**Tender No : TPCODL/P&S/100000294/2022-23**

**Empanelment of vendors for design, survey, supply, installation, testing, commissioning & 5 years comprehensive maintenance of distributed grid-connected solar PV power plants for solarisation of grid connected individual pumps under KUSUM Scheme – Component C**

**Replies to Pre Bid Queries**

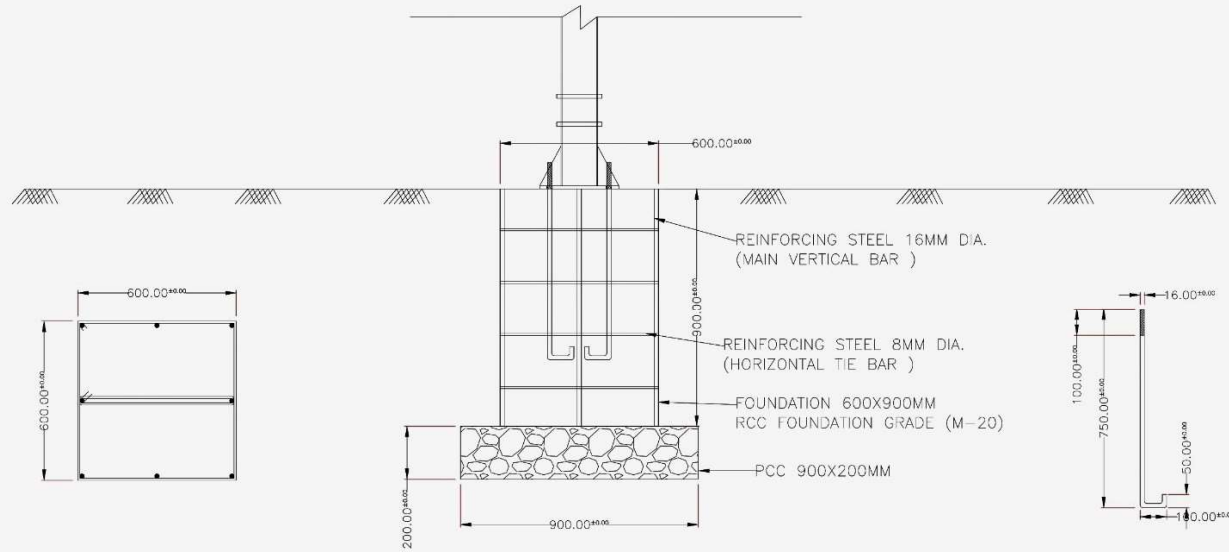
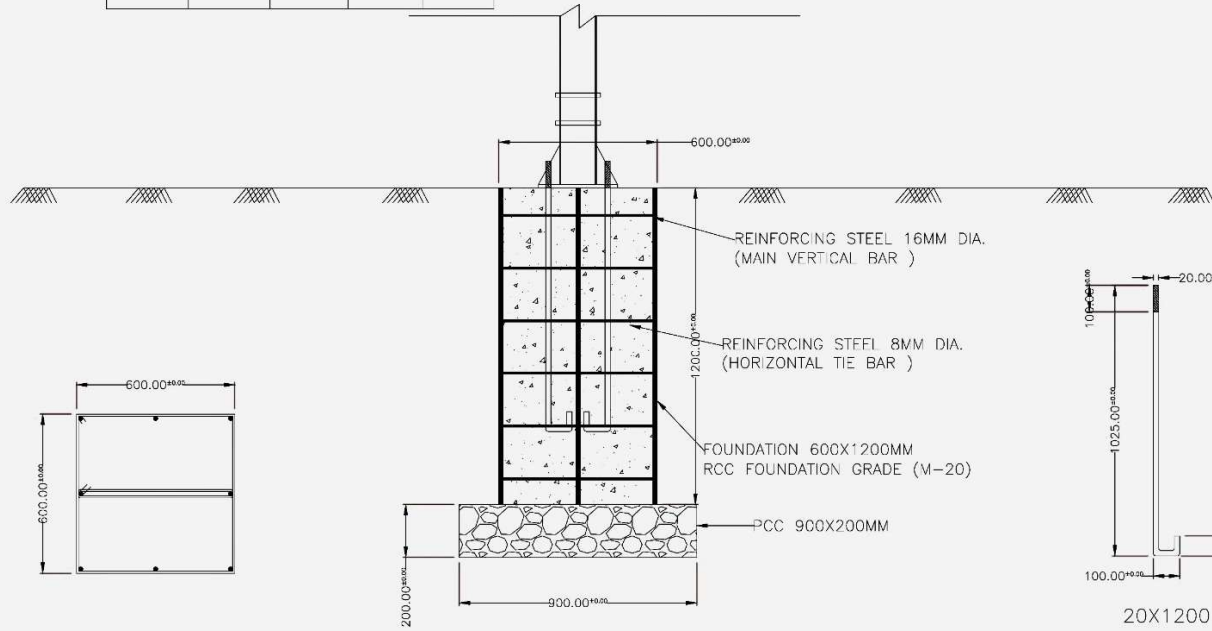
| Sl. No. | Clause No  | Page No | Clause Details  | Query   | TPCODL Replies to Queries   |
|---------|------------|---------|---|---|---|
| 45      | 15.1.4 (c) | 77/132  | The MMS foundation shall be constructed using RCC concrete pilefoundation of required diameter and depth based on approved design   | Bidder shall be allowed to use Steel Column embeded PCC pile fo the foundation.   | Refer Indicative Structural Drawing attached.   |
